Scrutiny plan
 Jp/3/6

PLAN SHOWING THE PROPOSED FIRST FLOOR AND SUBDIVISION TO THE APPROVED BUILDING IN PPA U30/189/81, BA U30/136/81 DT. 08.01.83 AT PLOT NO 102, S.NO. 704/5 & 704/6 OF 137, VELACHERY VILLAGE IN APPROVED LAYOUT NO 24/1973. SAIDAPET TALUK, CHENGAI-M.G.R. DT., MADRAS, FOR MRS - K. BAGAVATHI SUNDARI

FRONT ELEVATION

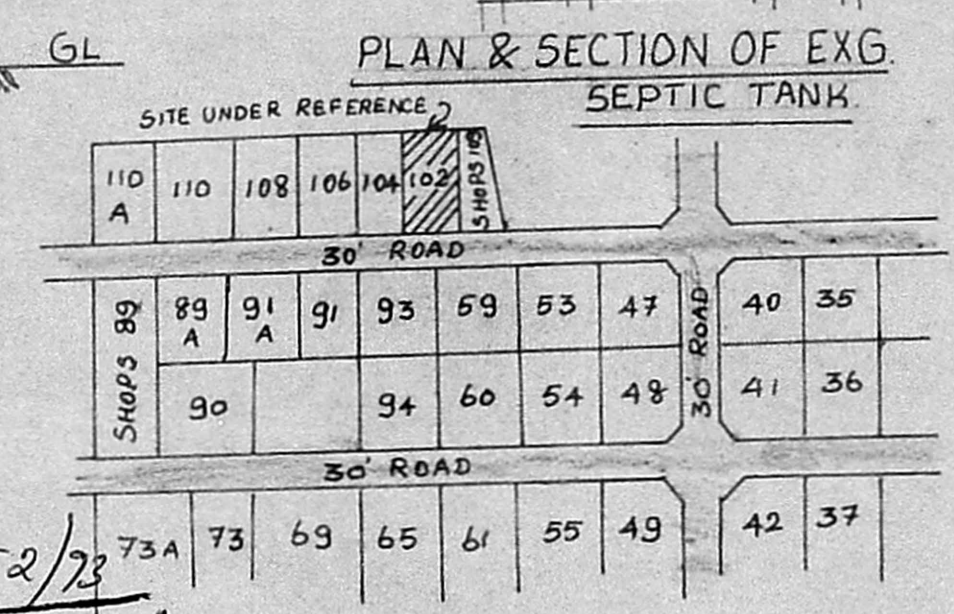
1) Breakup measurement
 2) Detail of well.
 3) Inspection report
 4) Copy of appd. to duly attested
 by local body official
 5) Copy of eng. bldg. approval plan
 attested by local body
 (or)
 original copy for verification.
